PRODUCT BULLETIN #534

CONSOLIDATION OF CAMSHAFTS IN AIR DRUM BRAKE AXLES

November 30, 2026

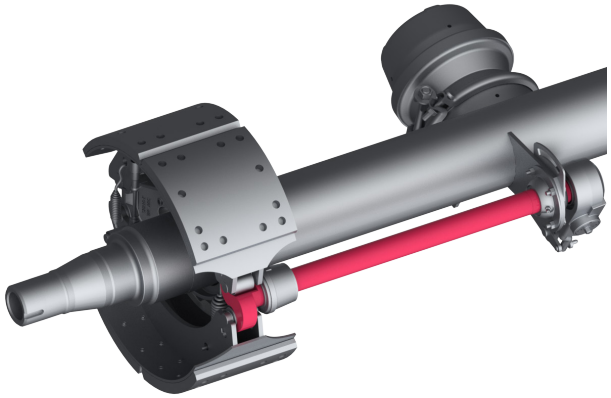
As a result of the consolidation, there are some minor length changes to some camshafts (found in the reference charts below) and an update to the head profile on the 12.25" size camshaft which leads to a new camshaft part number.

OLD STYLE	NEW STYLE

034-188-XX	034-220-XX
034-189-XX	034-221-XX

- All camshaft updates are backwards compatible in existing axle assemblies.
- The old style 12.25" camshaft is now obsolete will not be available to order.
- This is a running change in production as inventory runs out on each individual camshaft.
- Dexter recommends changing the camshaft in pairs, however there may be instances in the field where one side will be changed out and the axle will function properly.
